Bradley Heights

PROJECT DESCRIPTION
 SITE DEVELOPMENT IMPROVEMENTS, INCLUDING CLEARING, GRADING, RETAINING WALLS, PARKING LOT, STORM DRAINAGE, SANITARY SEWER MAIN, WATER MAIN FOR 238 UNIT MULTI-FAMILY DEVELOPMENT.

SITE ADDRESS:
 202 27TH AVE SE

Vault #2 Plan
 Bradley Heights
 Timberlane Partners
 1816 11th Ave Unit C
 Seattle, WA 98122
 Phone 509.896.0326
 Fax jordan@timberlanepartners.com

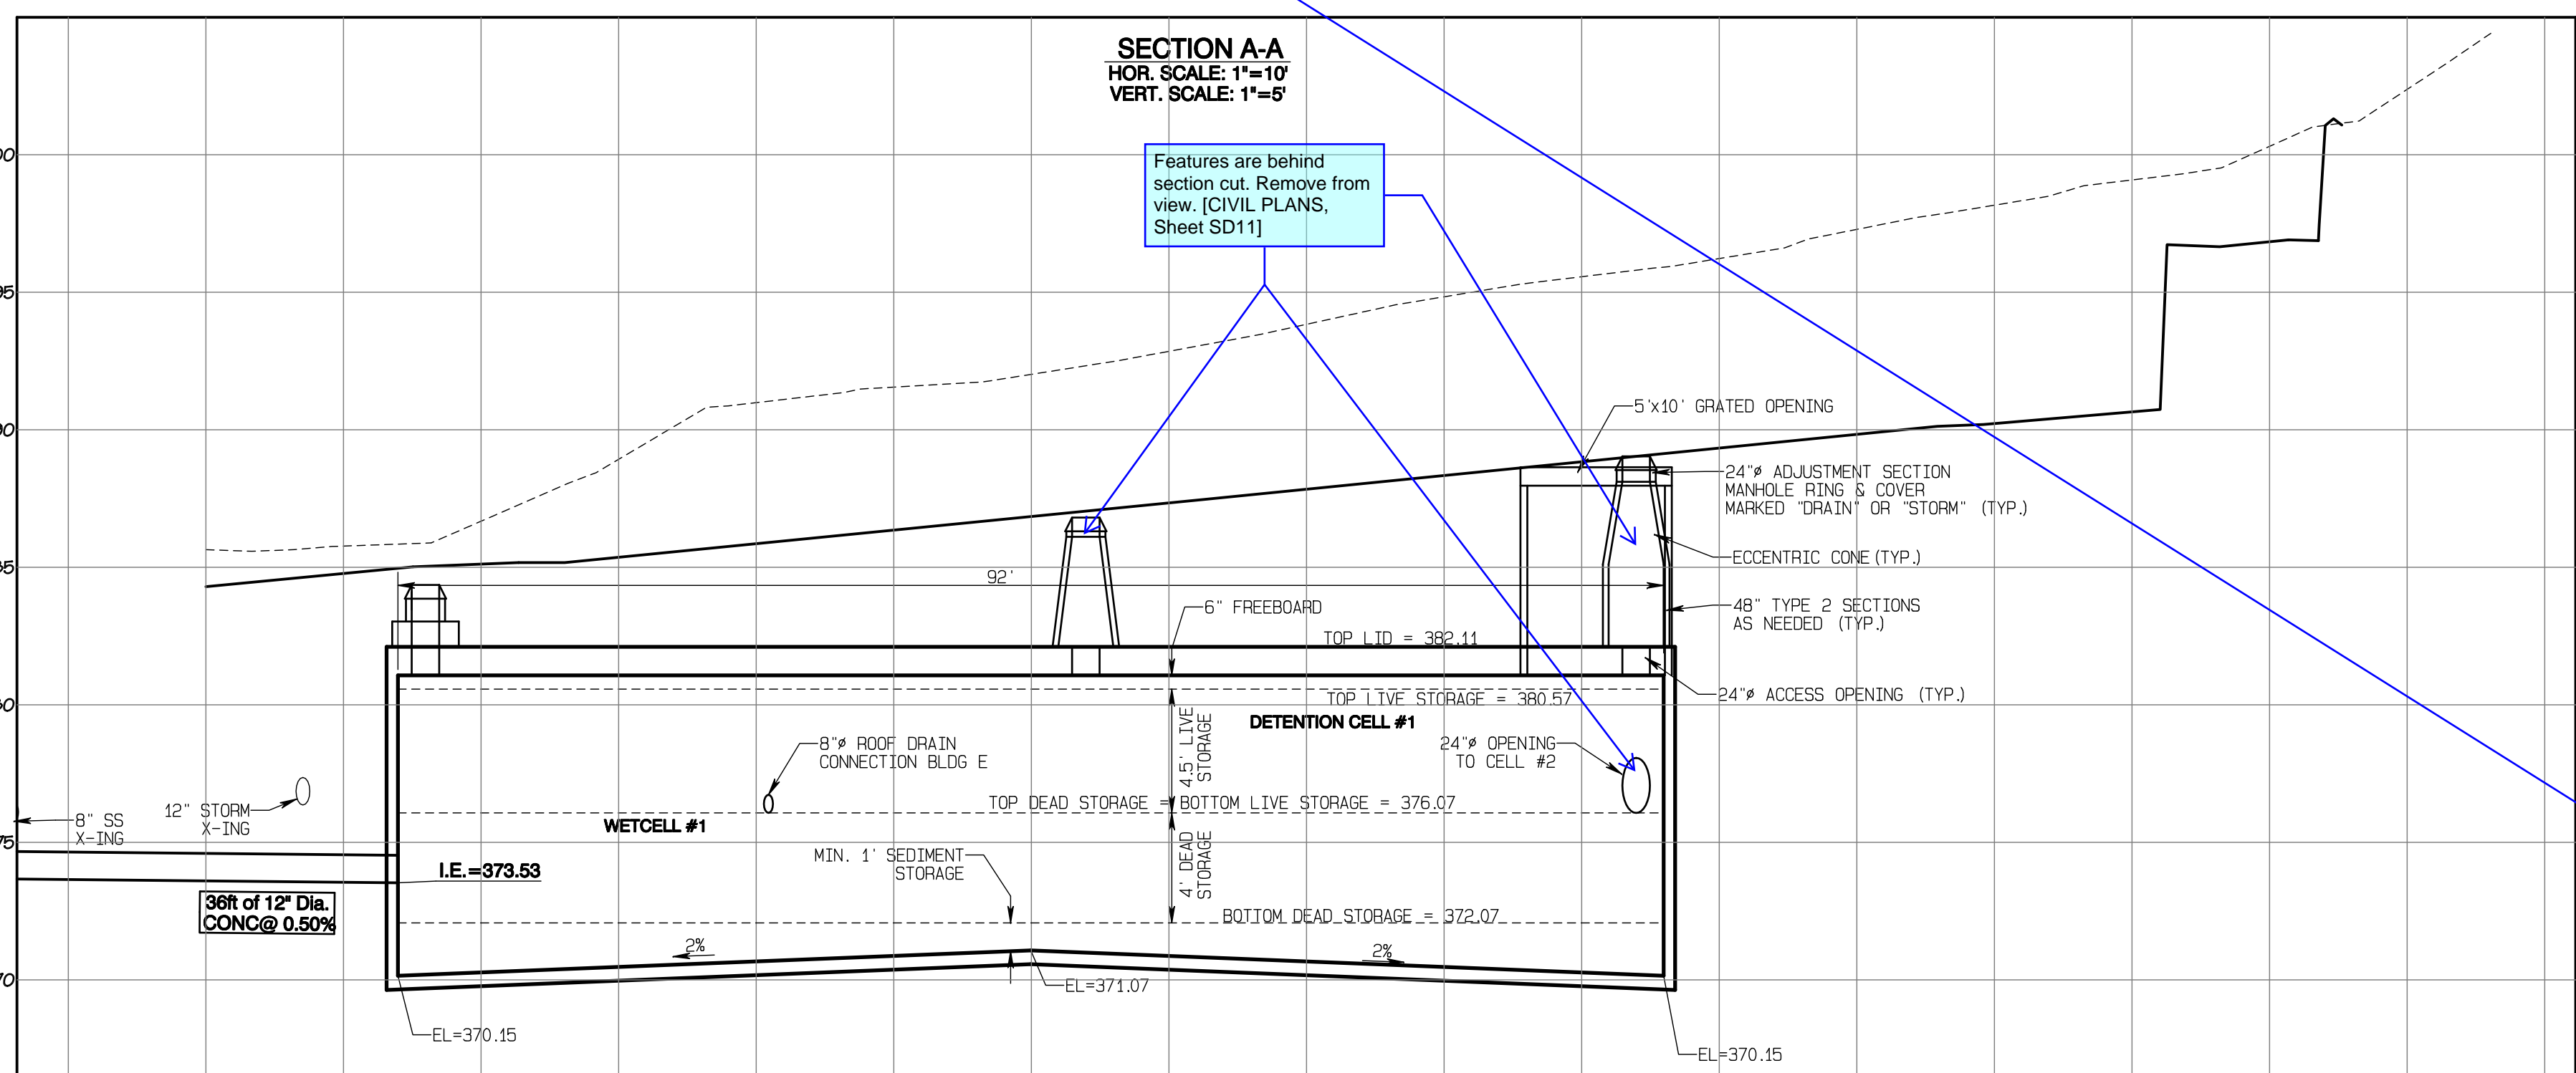
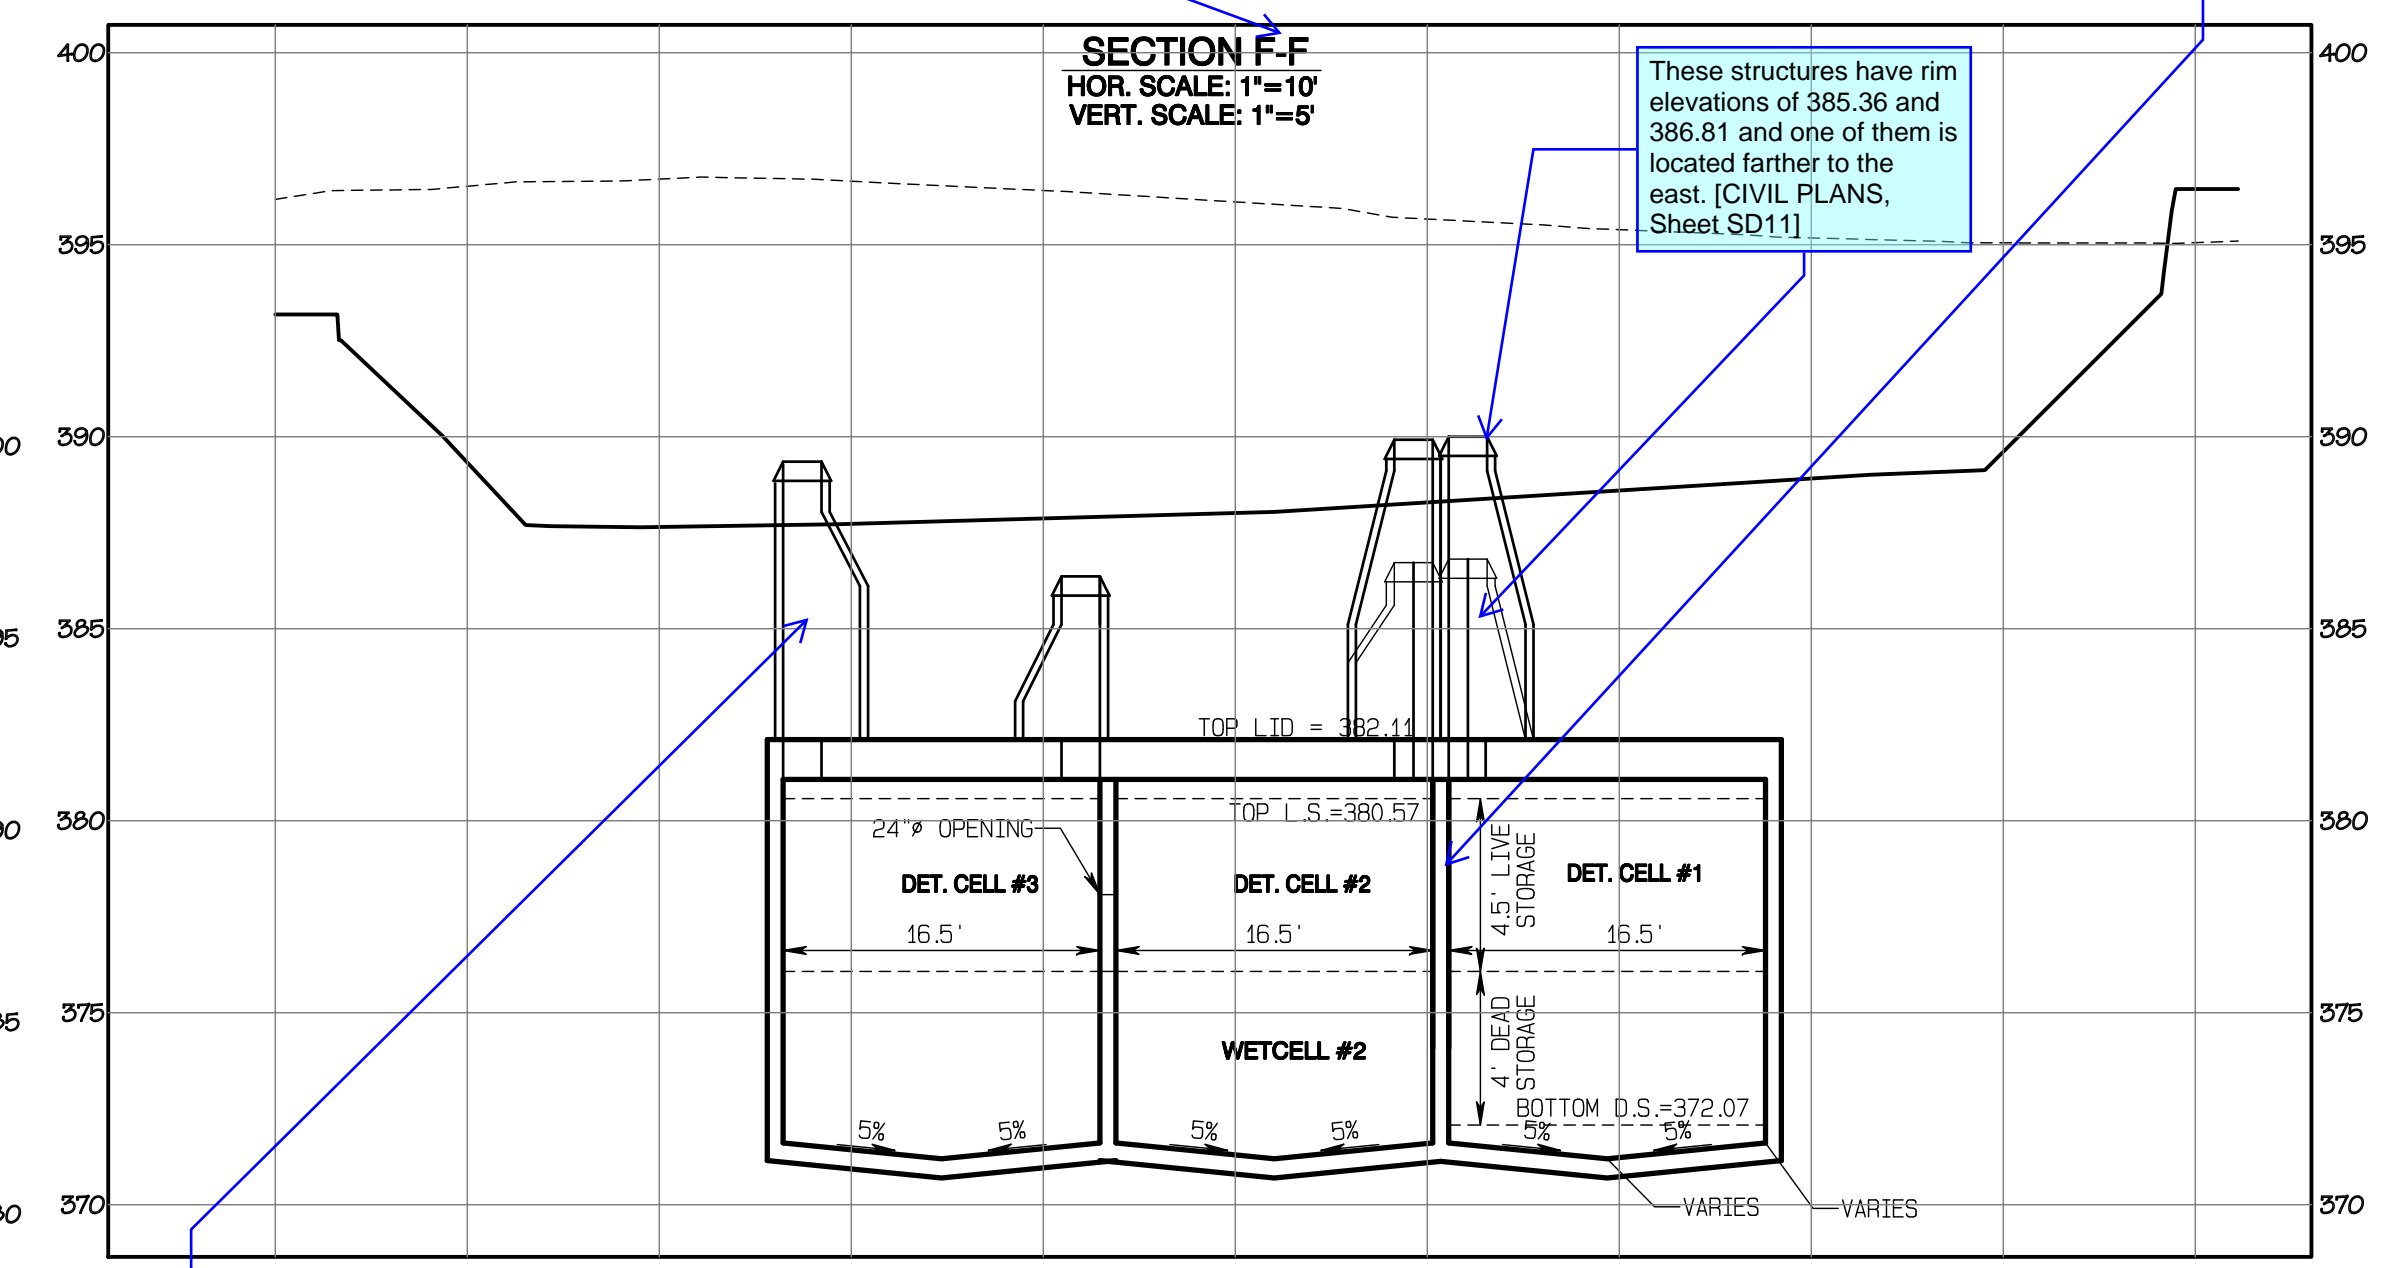
This structure has a rim elevation of 384.35. [CIVIL PLANS, Sheet SD11]

These structures have rim elevations of 385.36 and 386.81 and one of them is located farther to the east. [CIVIL PLANS, Sheet SD11]

E-E. [CIVIL PLANS, Sheet SD11]

Vault #3 Plan

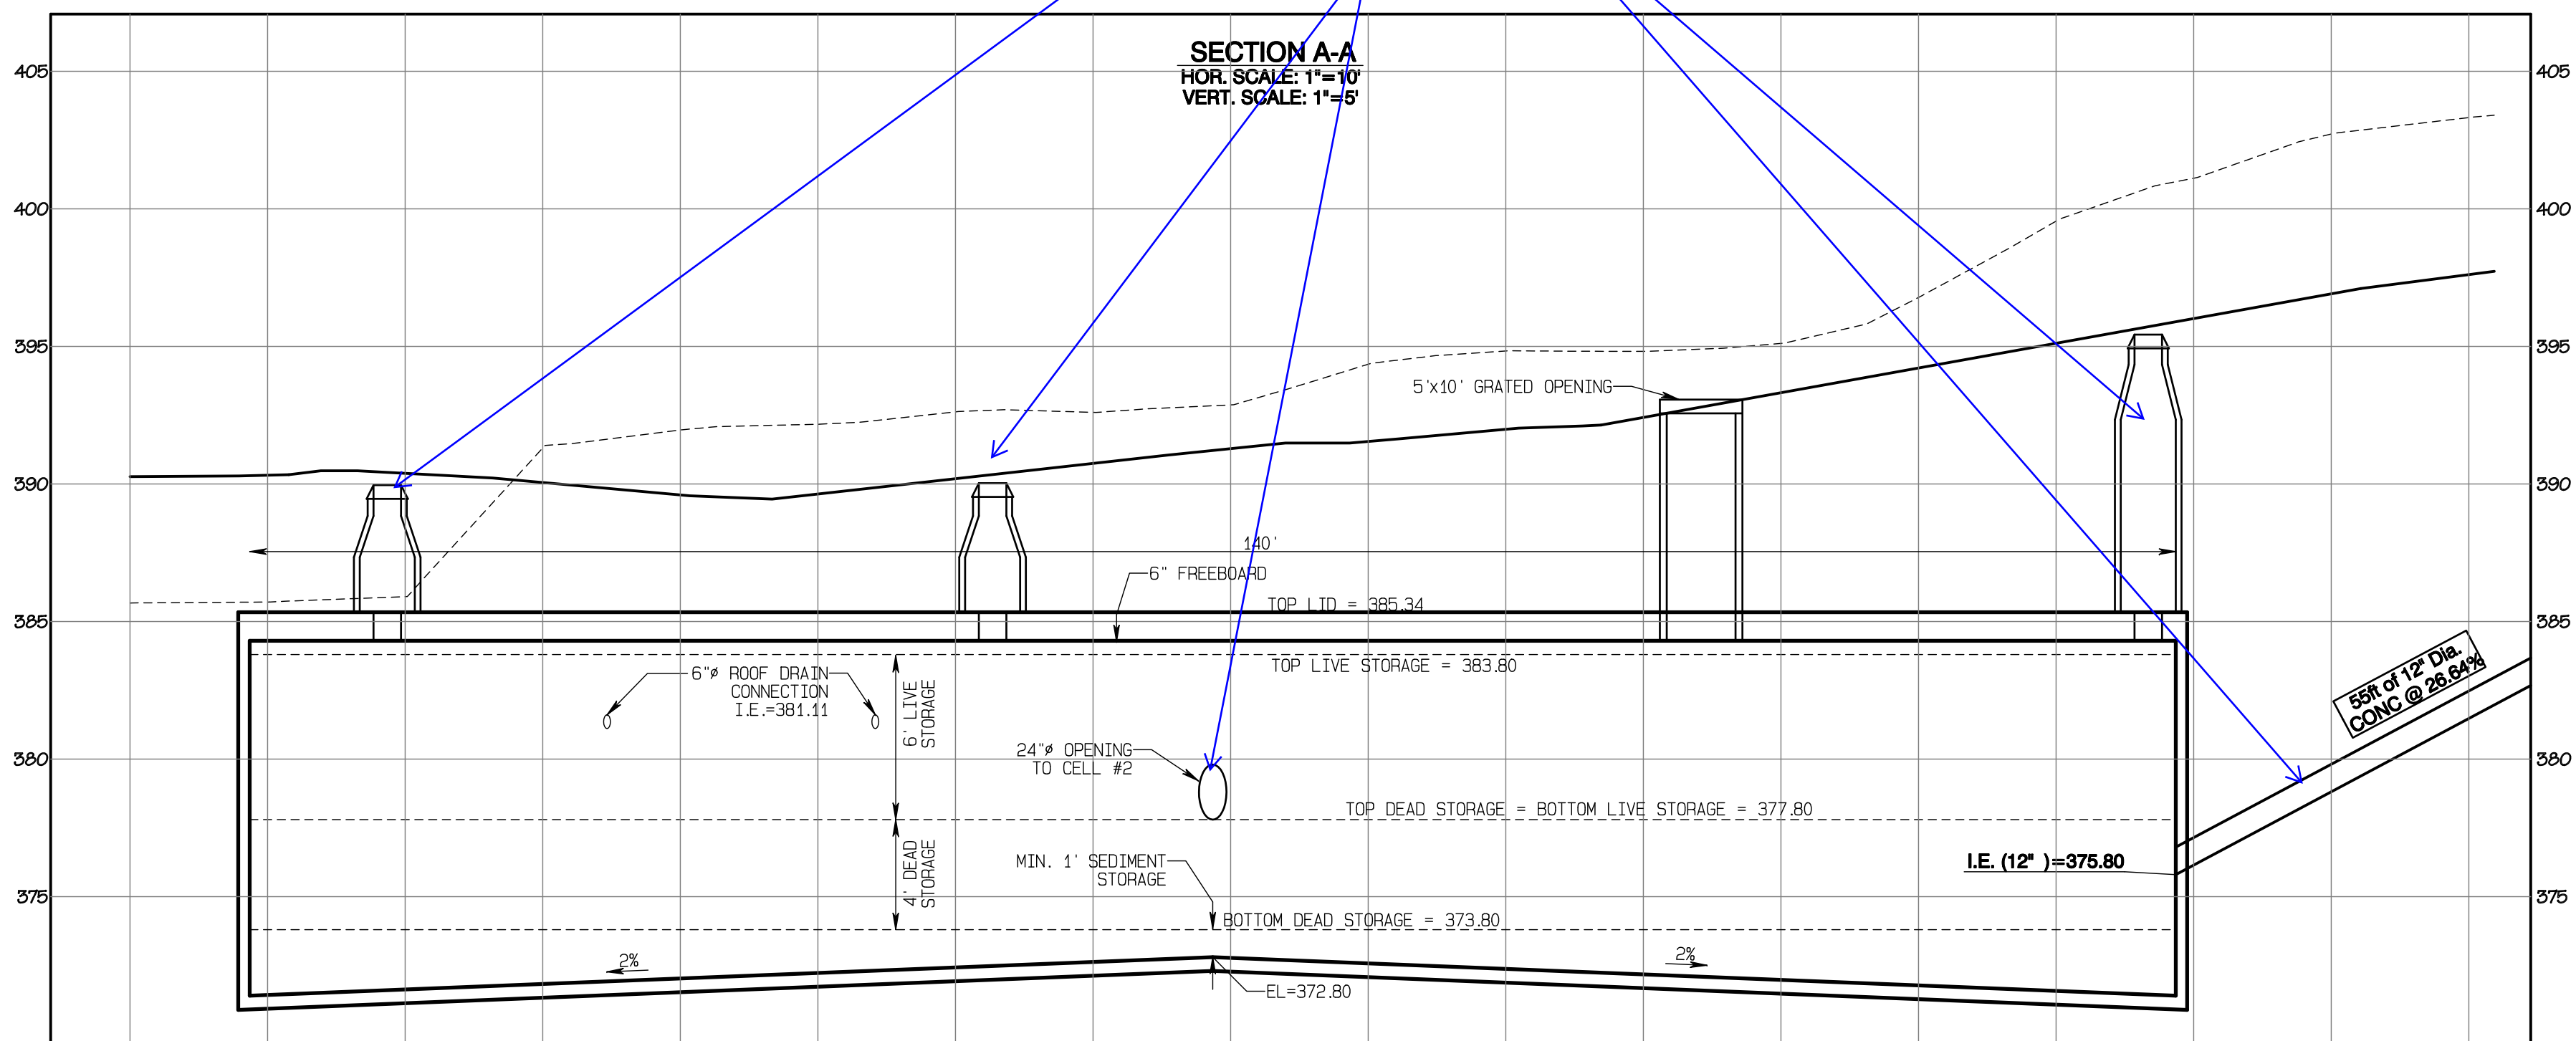
Features are behind Section Cut A-A. Remove from view. [CIVIL PLANS, Sheet SD13]
